# COUNTY COUNCIL'S RESPONSE TO CONSULTATION ON THE FOLLOWING DEVELOPMENT PROPOSAL

**Application No:** 19/00963/OUT-2

**Proposal:** Re-submission of application 17/02394/OUT - Outline planning permission for up to 40 dwellings with associated landscaping, open space and vehicular access off Berry Hill Road.

**Location:** East Of Last House Adjoining And North Of Berry Hill Road, Adderbury

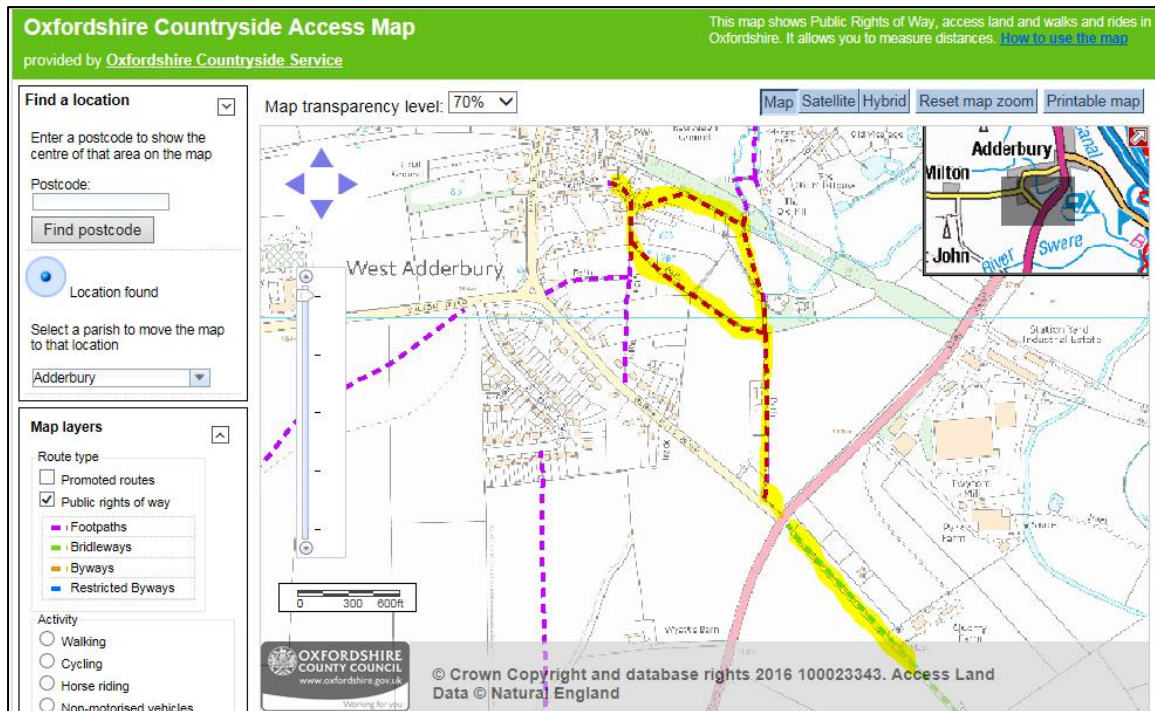
In the context of an outline application, all access arrangements need to be agreed at this stage. Besides the primary point of access, I am rather concerned by the lack of pedestrian access onto Berry Hill Road from the western part of the development.

I feel that the application has not taken advantage of its frontage to Berry Hill Road to enhance site permeability by providing a pedestrian connection which would be a direct and shorter path into the existing village. See below.

Without this provision, residents and visitors would have to walk back over 300m through the primary site access and the spine road a distance that should take a few metres from most dwellings. Application is strongly recommended to include this link. **(To be conditioned)**
